State of New Mexico  
 Energy, Minerals and Natural Resources

WELL API NO. 30-015-26448
5. Indicate Type of Lease STATE <input type="checkbox"/> FEE <input checked="" type="checkbox"/>
6. State Oil & Gas Lease No.
7. Lease Name or Unit Agreement Name Caviness Paine
8. Well Number: 2
9. OGRID Number 4323
10. Pool name or Wildcat Lovington, Brushy Canyon, East
11. Elevation (Show whether DR, RKB, RT, GR, etc.) 3008' GL

**SUNDRY NOTICES AND REPORTS ON WELLS**  
 (DO NOT USE THIS FORM FOR PROPOSALS TO DRILL OR TO DEEPEN OR PLUG BACK TO A DIFFERENT RESERVOIR. USE "APPLICATION FOR PERMIT" (FORM C-101) FOR SUCH PROPOSALS.)

**Caviness Paine 2  
Proposed P&A Wellbore Diagram**

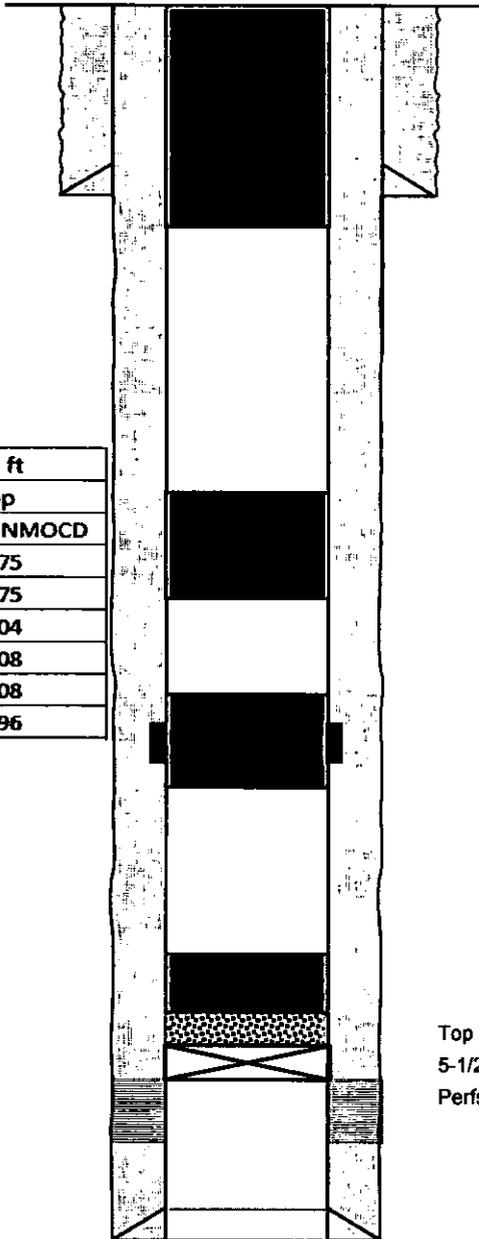
- MIRU & NU BOP
- TIH w/ workstring, tag TOC @ 5975', pressure test casing to 500 psi for 10 minutes - if the pressure test passes, spot MLF
- Spot 25 sx CL C cement f/ 5975' t/ 5747' (Upgrade Cement). If pressure test in Step 2 passes, ~~do not~~ WOC & tag. If pressure test in Step 2 failed, WOC, tag, pressure test to 500 psi for 10 minutes - if the pressure test passes, spot MLF; if the pressure test fails, contact engineer
- Spot 25 sx CL C cement f/ 3155' t/ 2927' (DV Tool)
- Spot 25 sx CL C cement f/ 2625' t/ 2697' (Lamar, B. Salt)
- Spot 65 sx CL C cement f/ 572' t/ surface (Shoe, T. Salt) *perf @ 572'*
- Verify TOC @ surface, RDMO, and turn over to site reclamation

*\*See Attached COAs* <sup>3/27/2019</sup>  
 X Nick Glann

APPROVED BY: *[Signature]* TITLE: *STA H Mg* DATE: *4/2/19*  
 Conditions of Approval (if any):
